SERVICE BULLETIN

NACELLE - POWER PLANT - MODIFICATION RECORD PLATES - REPLACEMENT OF - CATEGORY CODE 5 - MOD.NAC-71-0015

V2500-NAC-71-0015

Removal and Installation of the Mod Record Plate
Fig.1

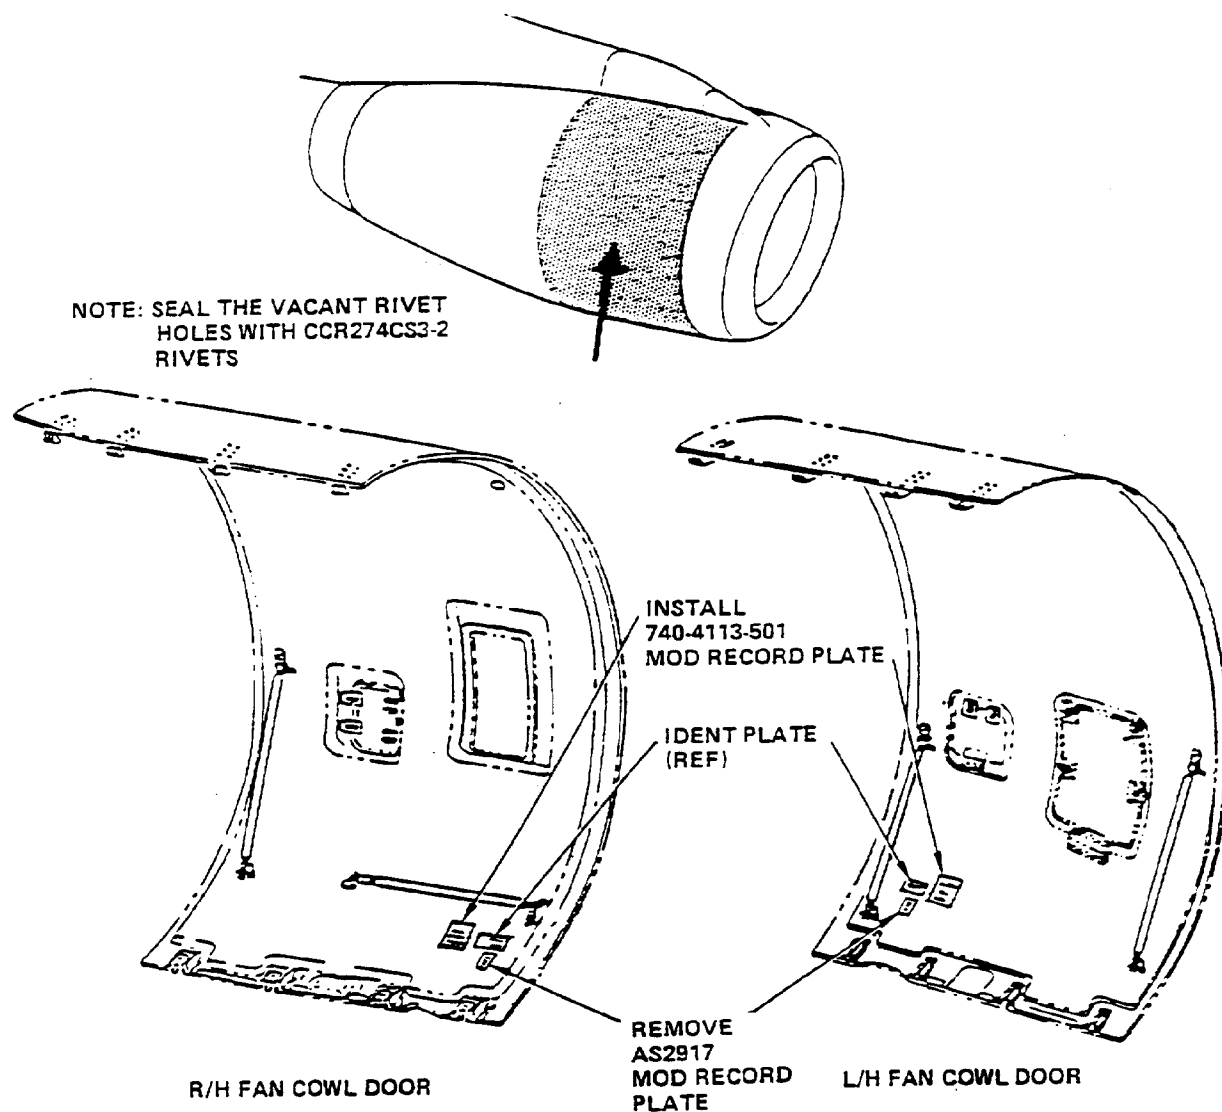
The modification record plates on the left and right fan cowl doors are removed and new plates are installed. Also, the modification record plate on the inlet cowl rear bulkhead is removed and a new plate installed.

- (a) Find the AS2917 modification (mod) record plate on the 740-4002-563 right fan cowl door and 740-4001-571 left fan cowl door. (Refer to Figure 1.) Remove four rivets to release the mod record plate.

- (b) Seal the four rivet holes in each fan cowl door with four CCR274CS3-2 rivets.
- NOTE: Use a 'drill stop' to make sure that the drill goes through the inside skin only.

- (c) Hold the new 740-4113-501 mod record plate in the approximate position shown on the fan cowl door. Use the mod record plate as a template and drill four holes 0.098 inch (2.50 mm) diameter into the fan cowl door. Remove any burrs from the holes.

- (d) Apply PL32 Hylomar jointing compound to the bottom face of the 740-4113-501 mod record plate. Rivet the mod record plate in position with four CCR274CS3-2 rivets. Remove any unwanted Hylomar with a clean rag.

- (e) Copy the modification record onto the new mod record plate from the old. Discard the old mod record plate.
- (f) Reidentify the left fan cowl door to 740-4001-575. Reidentify the right fan cowl door to 740-4001-567.

Removal of the Mod Record Plate (Non Fire Resistant)
Fig.2

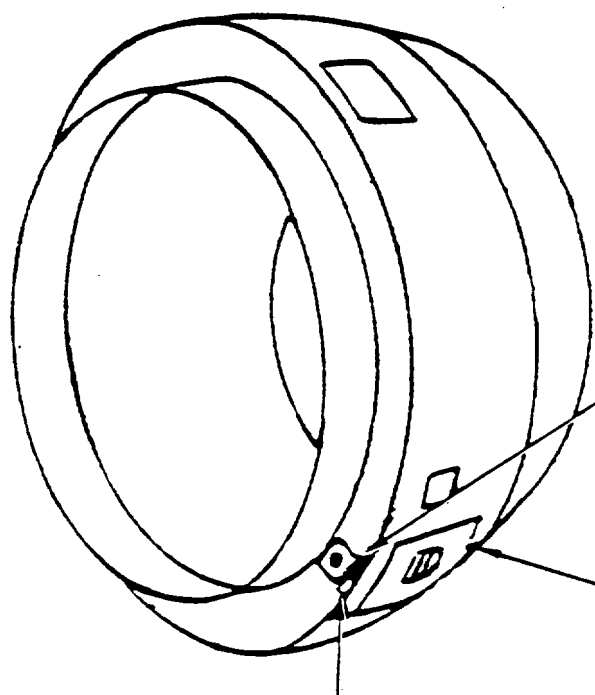
REMOVE
AS2917 MOD RECORD PLATE
(SEAL THE VACANT RIVET HOLES
WITH CR3523-5-4 RIVETS)

- (a) Find the AS2917 mod record plate on the 740-3000-573 inlet cowl rear bulkhead. (Refer to Figure 2.) Remove four rivets to release the mod record plate.

- (b) Seal the four rivet holes in the bulkhead with four CR3523-5-4 rivets.
- (c) Remove rivets as necessary from the 1-07752-00-00 insulation blanket to gain access to rivets at locations (A) and C. (Refer to Figure 3.)

Modification of the Insulation Blanket (to Install the Mod Record Plate)
Fig.3

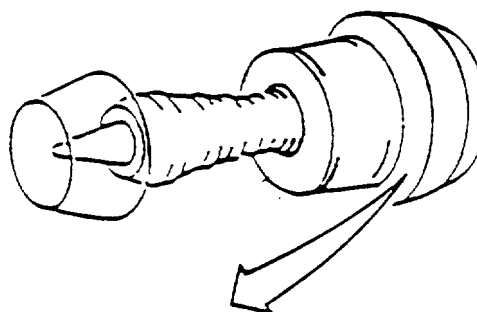
- (d) Remove rivets from locations C and (A).
- (e) Increase the hole dimension at location (A) to 0.200 inches (5.1 mm) diameter in the insulation blanket and the bulkhead. Remove any burrs from the holes.

- (f) Install the 740-3254-501 mod record plate with the 1-07752-00-00 insulation blanket to the bulkhead as follows:
 - 1 Apply PL32 Hylomar jointing compound to the bottom face of the mod record plate.

- 2 Use the fasteners shown on Figure 3 to install the insulation blanket with the mod record plate on the bulkhead.
 - 3 Remove any unwanted material or debris from inside the inlet cowl; get access through the TAI exhaust panel.
